SERVICE BULLETIN

POWER PLANT - NACELLE - POWERPLANT - DRAIN TUBES AND COLLECTOR PLATE ASSEMBLY -
REPLACEMENT OF - CATEGORY CODE 6 - MOD.NAC-71-0169

V2500-NAC-71-0169

INSTALLATION OF DRAIN TUBES
Fig.1 (SHEET 1)

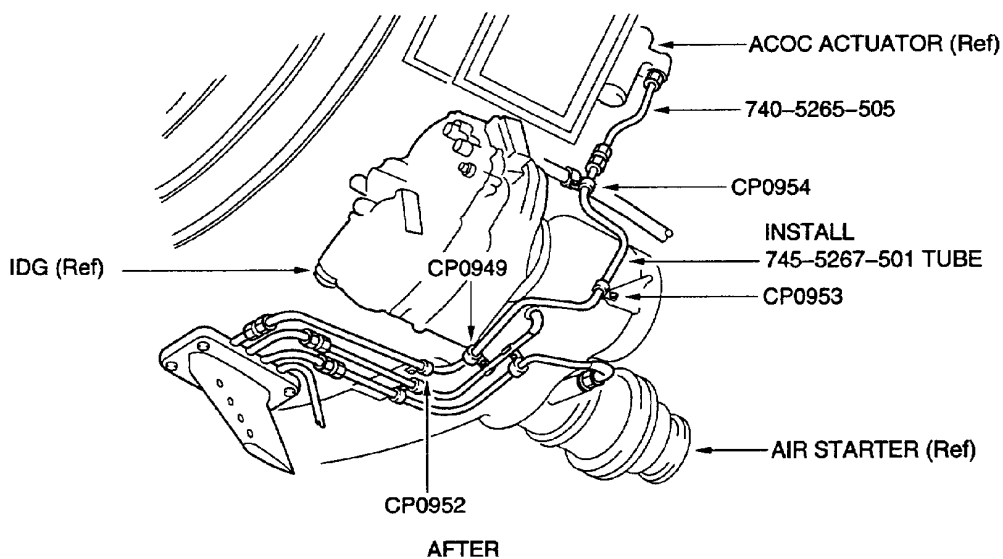
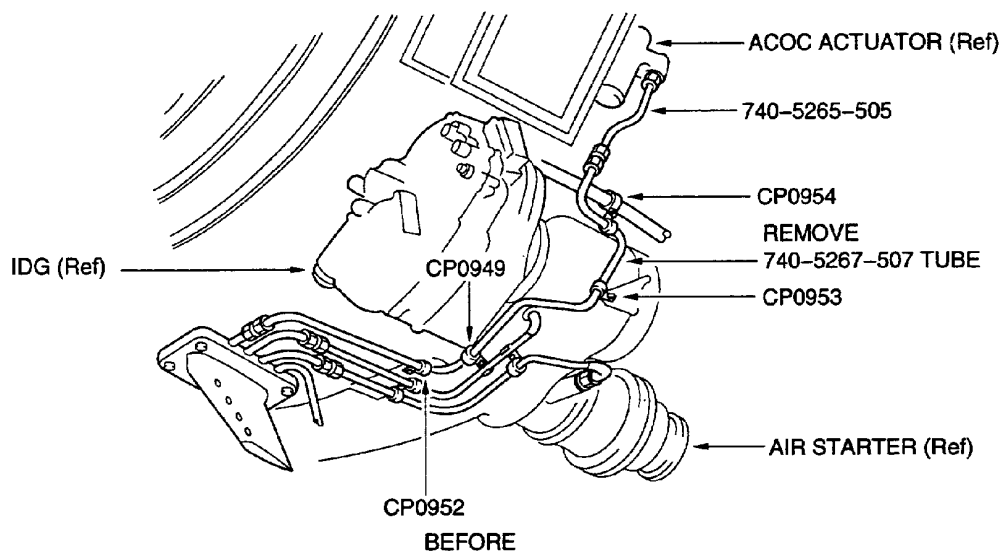
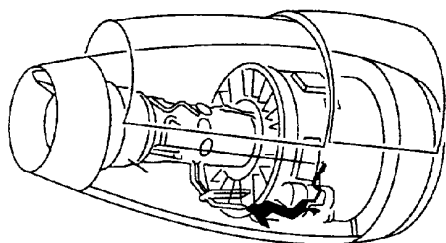
- (1) Install the 745-5267-501 tube as shown. Hand tighten the couplings only at this stage (Refer to Figure 1, Sht 1).
- (2) Install the 745-5688-501 tube (from the Bifurcation Panel) as shown. Hand tighten the couplings only at this stage (Refer to Figure 1, Sht 2).
- (3) Install the new 745-5682-501 Collector Plate Assembly as instructed in the V2500/A320/A321 Aircraft Maintenance Manual, Task 71-71-42-410-010.

REMOVAL/INSTALLATION OF CLIPPING POINTS
Fig.1 (SHEET 3)

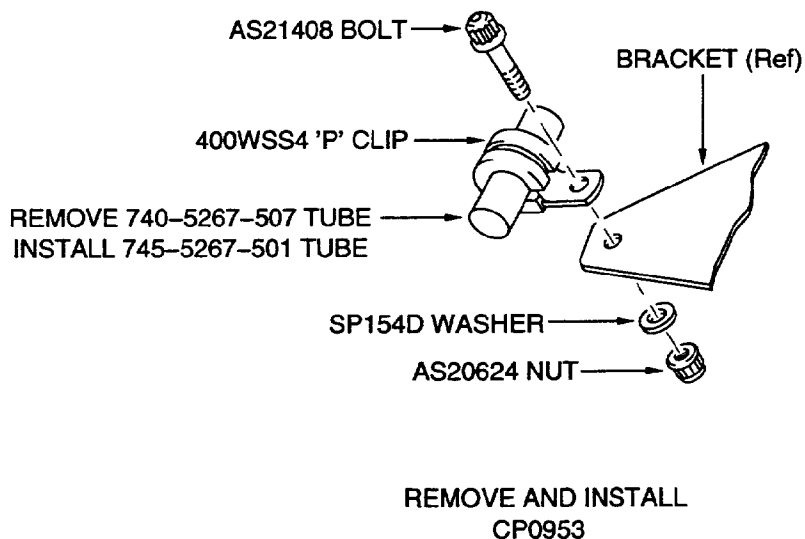
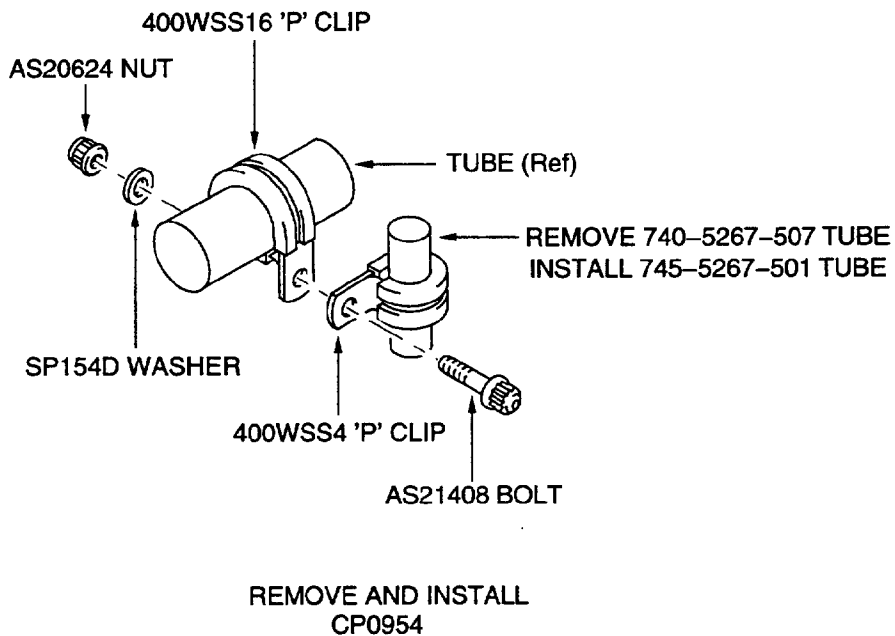
Assemble clipping point CP0954 as shown with an AS21408 Bolt, 400WSS4 'P'Clip, 400WSS16 'P'Clip, and AS20624 Nut and an SP154D Washer (Refer to Figure 1, sheet 3).

(5) Assemble clipping point CP0953 as shown with an AS21408 Bolt, 400WSS4 'P' Clip, an AS20624 Nut and an SP154D Washer.

REMOVAL/INSTALLATION OF CLIPPING POINTS
Fig.1 (SHEET 4)

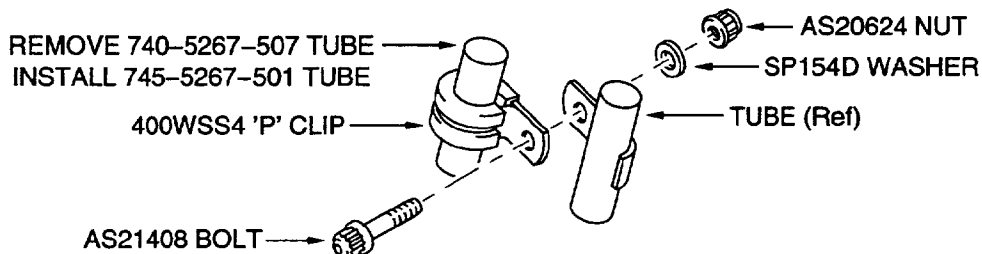
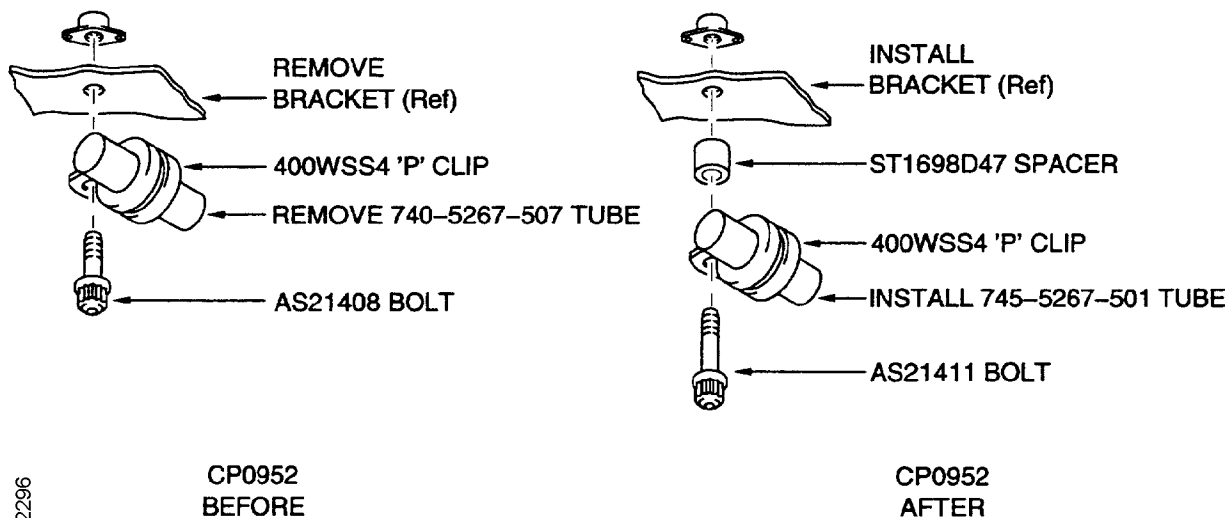
(6) Assemble clipping point CP0949 as shown with an AS21408 Bolt, 400WSS4 'P' Clip, an AS20624 Nut and an SP154D Washer. (Refer to Figure 1, sheet 4).

(7) Assemble clipping point CP0952 as shown with a new AS21411 Bolt, 400WSS4 'P'Clip and a new ST1698D47 Spacer.

CP0968
BEFORE

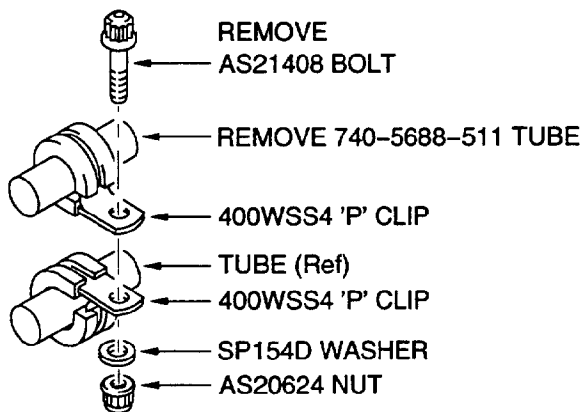
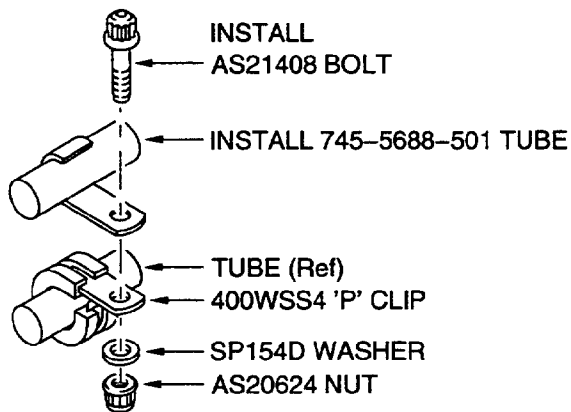
(8) Assemble clipping point CP0968 as shown with an AS21408 Bolt, 400WSS4 'P' Clip, AS20624 Nut and an SP154D Washer. (Refer to Figure 1, sheet 5).

CP1396
REMOVE AND INSTALL

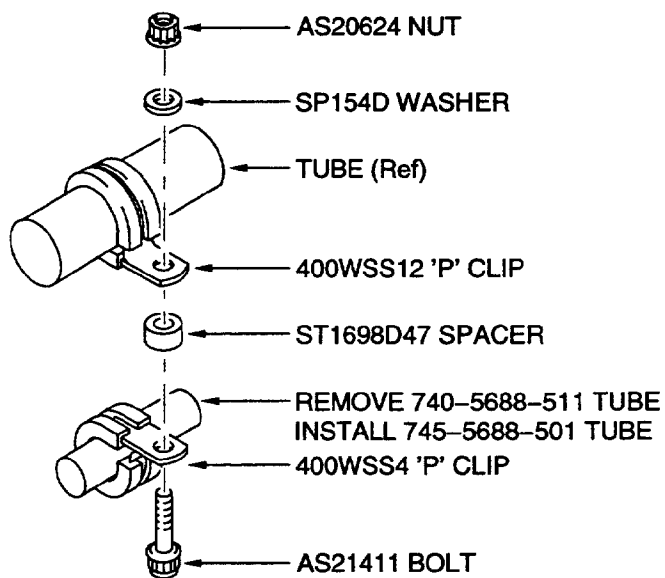
(9) Assemble clipping point CP1396 as shown with an AS21411 Bolt, 400WSS4 'P'Clip an 400WSS12 'P' Clip an ST1698D47 Spacer an AS20624 Nut and an SP154D Washer.

CP1169
BEFORE

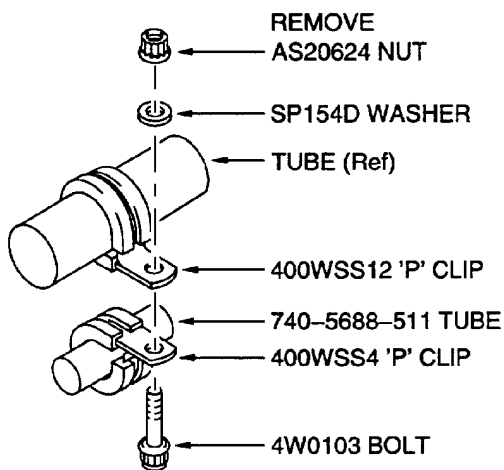
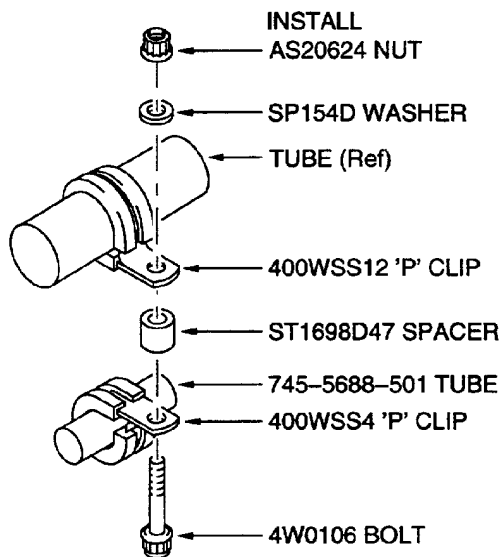
(10) Assemble clipping point CP1169 as shown with a new 4W0106 Bolt, 400WSS4 'P' Clip an 400WSS12 'P' an AS20624 Nut and an SP154D Washer. (Refer to Figure 1, sheet 6).

CP0937
BEFORE

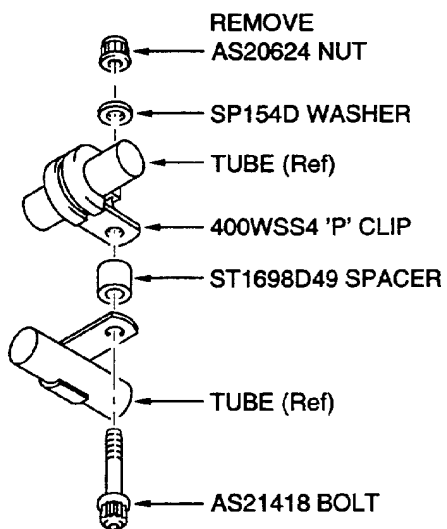
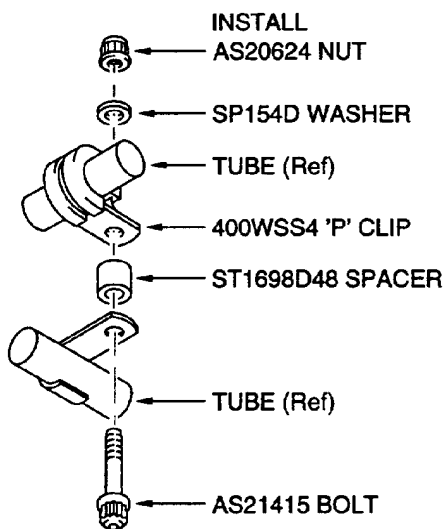
(11) Assemble clipping point CP0937 as shown with a new AS21415 Bolt, 400WSS4 'P' Clip a new ST1698D48 spacer an AS20624 Nut and an SP154D Washer.
